QER 11066

QER: MERAKES EAST PROJECT SF216608C002.06 - Longitudinal scratches on zeta wire

Item	Traceability / identification
Project number	SF216608C002
Project name	MERAKES EAST PROJECT
Pipe section	SF216608C002.06
ST number	ST254.72048
Affected layer / equipment	Zeta vault spiralling
Length affected	806.8m until 809.4m
Drawing number / MP code / STA / Dimension	ZETA 12 FI 11(MP746)

Figure 1 : Longitudinal scratches on zeta wire was detected at start length 806.8m until 809.4m on pipe.

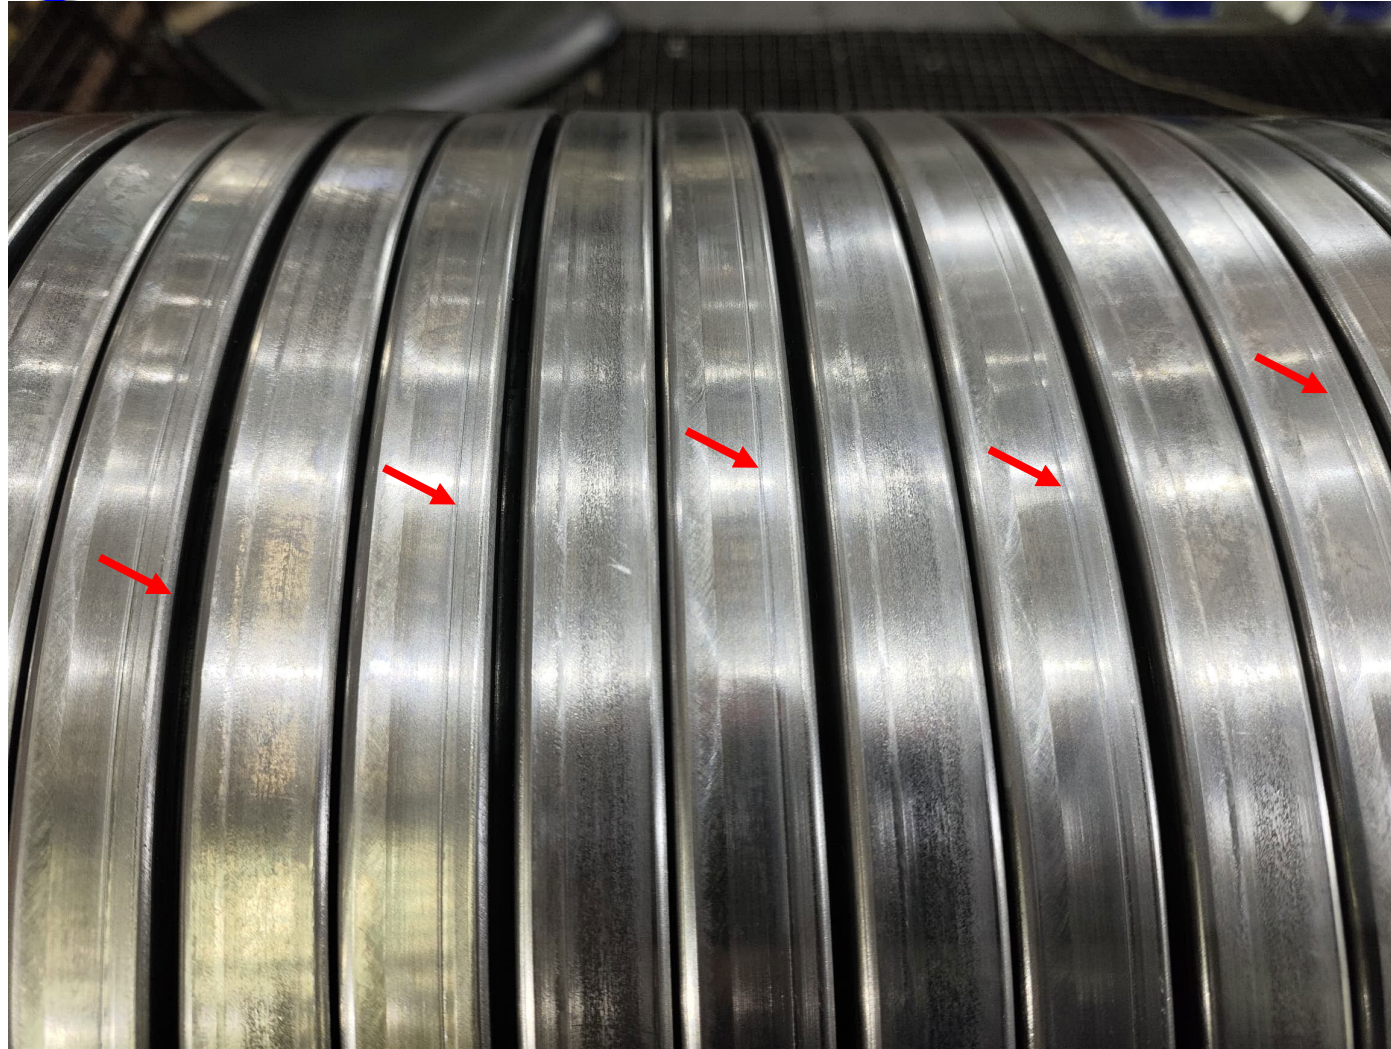
During the zeta spiraling of MERAKES EAST PROJECT SF216608C002.06 (ST254.72048), longitudinal scratches on zeta wire was detected at start length 806.8m until 809.4m on pipe.

- Depth: 57um
- Upsetting: 68um

Figure 2 : The Scratches was observed from incoming wire in bobbin #011, Therefore, the bobbin was replaced and quarantine for further investigation.

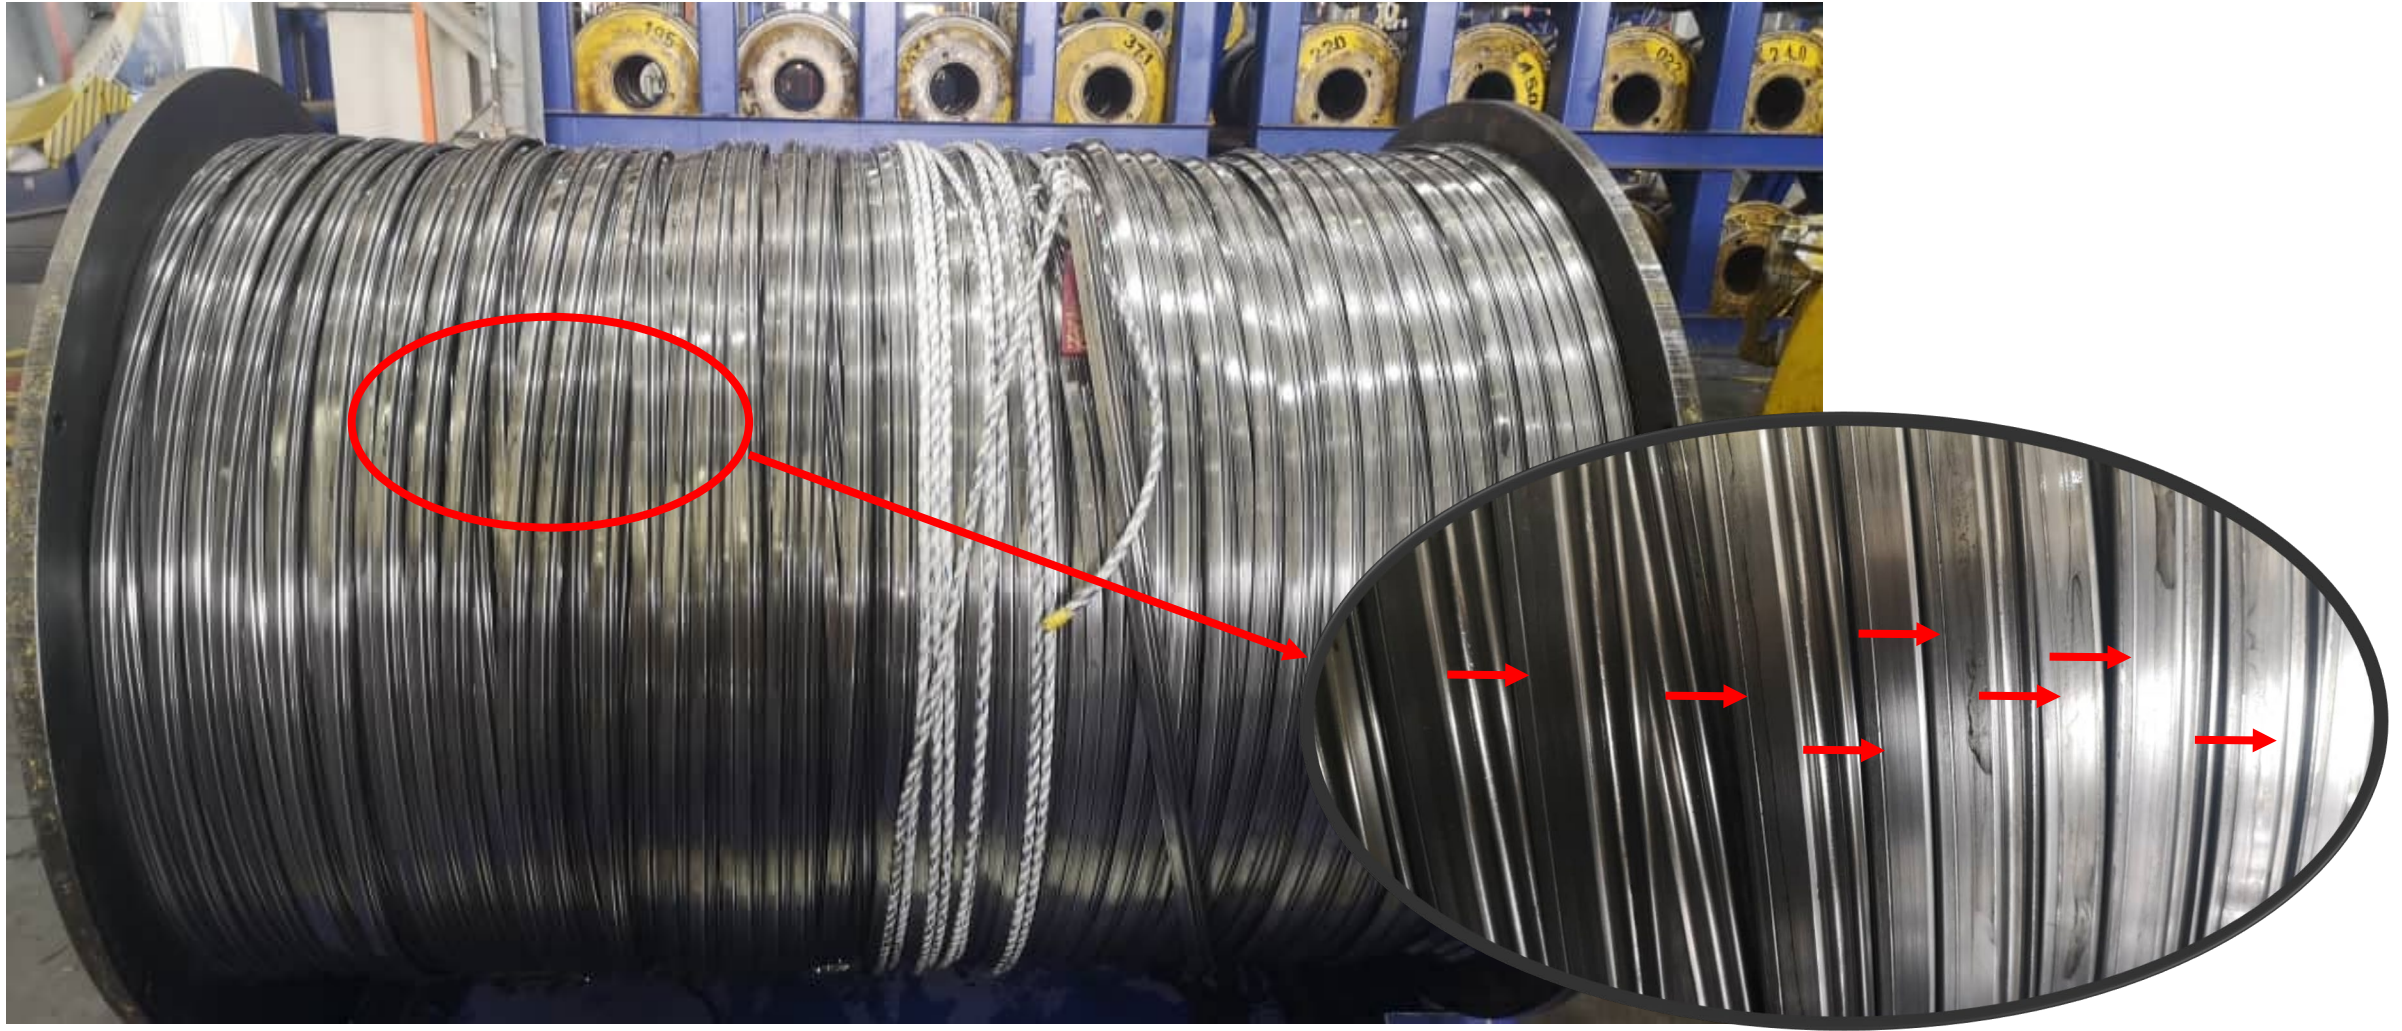
The Scratches was observed from incoming wire in bobbin #011, Therefore, the bobbin was replaced and quarantine for further investigation.

1. Suspect wire escape from path of roller and make contact to locking roller at accumulator
2. Suspect wire escape from path of roller at straightener roller.

Figure 3 : According to project acceptance criteria CD_216608C002_str25472048_TR01-09_rev0_An_Pressure vault, the maximum allowable criteria for the depth of surface defects is 100μm and for the maximum upsetting is 50μm.

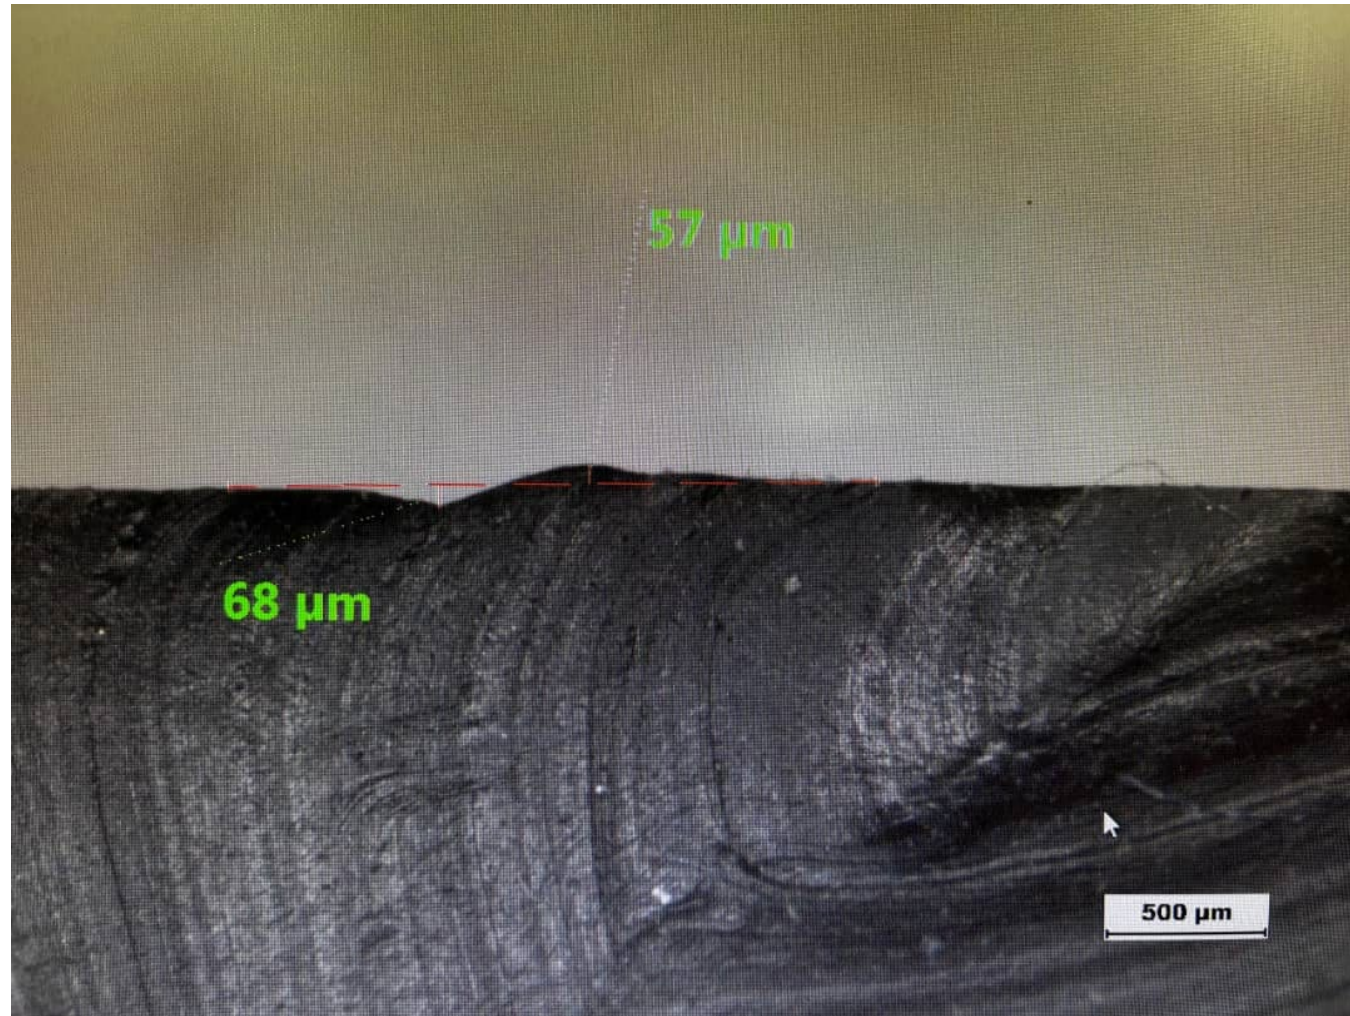
According to project acceptance criteria CD_216608C002_str25472048_TR01-09_rev0_An_Pressure vault, the maximum allowable criteria for the depth of surface defects is 100um and for the maximum upsetting is 50um. Thus, this defect depth was accepted as it is. However, the upsetting defect has been removed by buffing.

Figure 4 : Defect depth was accepted as it is. However, the upsetting defect has been removed by buffing.
